Site Accessibility Evaluation

**North Academy Super Stop
PU18-0079**

SUBJECT: North Academy Super Stop Self-Evaluation

Image of vertical displacement in sidewalk

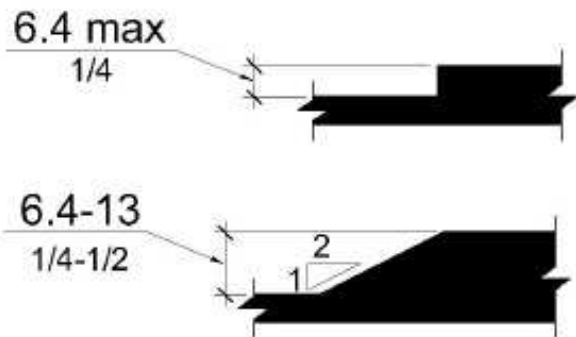
Finding: 1

The surface of the pedestrian access route has vertical discontinuities greater than 1/2 inch or between 1/4 inch and 1/2 inch that are not beveled.

2011 PROWAG Section R302.7.2

There is 3/4" vertical displacement around the utility vault in the sidewalk.

Remove and replace the concrete panels around the vault, or re-set the vault flush with the concrete surface.

Image of narrow sidewalk

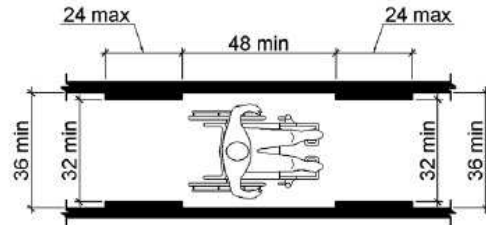
Finding: 2

There is displacement between the sidewalk and curb.

2010 ADAS Section 403.5.1

There is 33-1/2" between the vault and the inside edge of the curb.

The width will be addressed if the panels are replaced and made flush with the utility vault.
